UNITED STATES PATENT AND TRADEMARK OFFICE

APPLICATION NO.	FILING DATE	FIRST NAMED INVENTOR	ATTORNEY DOCKET NO.	CONFIRMATION NO.
10/797,814	03/10/2004	Jorg-Reinhardt Kropp	075791.0235	7472
5073	7590	04/15/2008	EXAMINER	
BAKER BOTTS L.L.P.			LIU, LI	
2001 ROSS AVENUE				
SUITE 600			ART UNIT	
DALLAS, TX 75201-2980			PAPER NUMBER	
			2613	
			NOTIFICATION DATE	
			DELIVERY MODE	
			04/15/2008	
			ELECTRONIC

Office Action Summary	Application No. 10/797,814	Applicant(s) KROPP, JORG-REINHARDT	
	Examiner LI LIU	Art Unit 2613

DETAILED ACTION

Figure O1

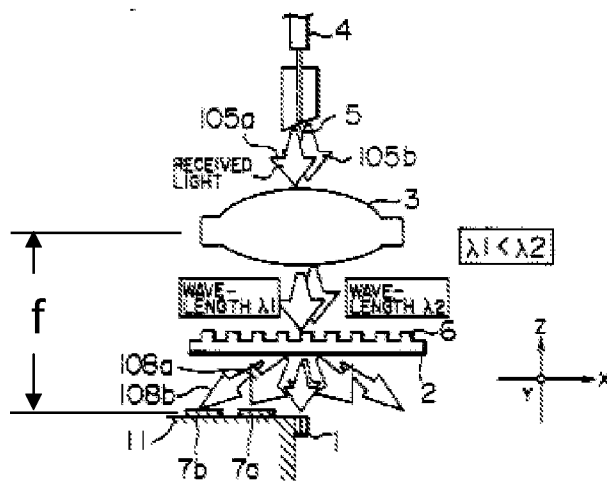
As shown in Figure O1 (or the Figure 7 of Ohnishi), the light receiving devices 7a and 7b are at the same plane. Since the location of the focus depends on the wavelength, if the “f” shown in Figure O1 is the focal plane for λ_1 and the 7a is at the focal plane of the λ_1 , then the receiving device 7b is not at the focal plane for λ_2 ; correspondingly if the “f” is the focal plane for λ_2 and the 7b is at the focal plane of the λ_2 , then the receiving device 7a is not at the focal plane for λ_1 . That is at least one of the receiving devices is not at the focal plane of its receiving wavelength. Or at least one of the receiving components is located away from the location where the diffraction structure concentrates the received light.

3). Applicant's argument – “Third, in response to Applicant's previous arguments, the Examiner created Figures O 1 and O2 and discussed them in the Office Action. Office Action, p. 3-4. These figures are not found in *Ohnishi* or any other reference cited by the Examiner. The Examiner uses these figures to show that "it is not necessary for the receiving diode to be placed at the focus of the diffraction structure." However, the Examiner fails to provide any evidence, other than Examiner's own figures and discussion, or cite any prior art reference for this assertion. Examiner's figures do not qualify as prior art under any patent statute. Additionally, as described below, Examiner's figures are not representative of any reference cited by the Examiner.

4). Applicant’s argument – “The Examiner appears to use figures O1 and O2 as a substitute for the teachings of *Ohnishi*. Office Action, p. 4. However, although Examiner's figures show two receiving devices, the two receiving devices are structured and utilized differently than the two receiving devices in Figure 7 of *Ohnishi*. The Examiner use of these constructed figures misrepresents the discussion in *Ohnishi*. Office Action, p. 3-4. *Ohnishi* uses two receiving devices when utilizing **more than one received light beam**, as described above. *Ohnishi*, Col. 9, lines 30-54. The Examiner's constructed figures only show one received light beam, in contrast to *Ohnishi*, and thus are irrelevant for the purposes of describing what *Ohnishi* discloses.”

Examiner’s response – Both *Ohnishi* and *Kuhara* teaches to use a photodiode with relatively large light receiving surface. The Figures O1 and O2 in the previous Office Action clearly show that due to a large receiving area of the photodiode, even through the receiving device is located away from the focus, all the receiving light is still substantially impinged on the receiving device. It is different from the photodiode with small receiving area that would not receive all the light when moved away from the

Figure O2

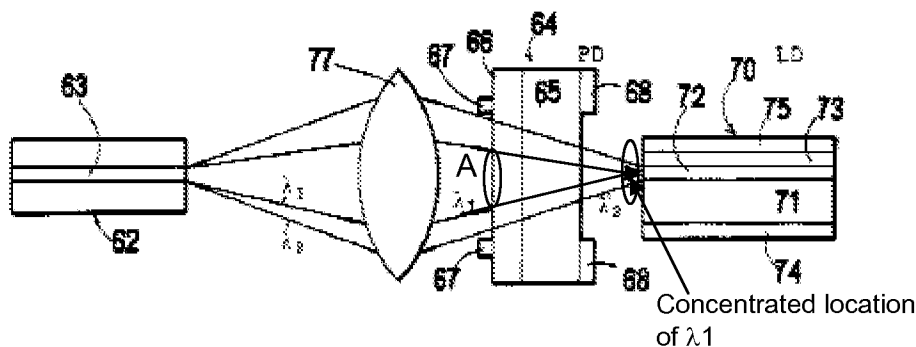
5). Applicant's argument – "Kuhara fails to cure the deficiencies of Ohnishi".

Examiner's response – Refer to the Figure 11 or the following Figure O2:

Kuhara teaches that the receiving component (66 in Figure O2) is located away from the location (the location indicated as "Concentrated location of λ_1 ") where the diffraction structure concentrates the received light at the second wavelength (λ_1).

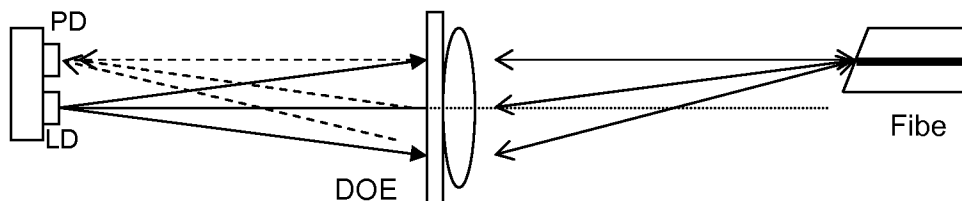
When the fiber end is cut at an angle of 8 degrees, due to the refraction the center axis of the input and output light will be tilted by a small angle with respect to the fiber core axis. Refer to following figure, if the diffractive lens is not arranged laterally offset with respect to the optical waveguide axis, the center of the intensity distribution of the light beam will not meet the center of the diffractive lens and power loss will occur.
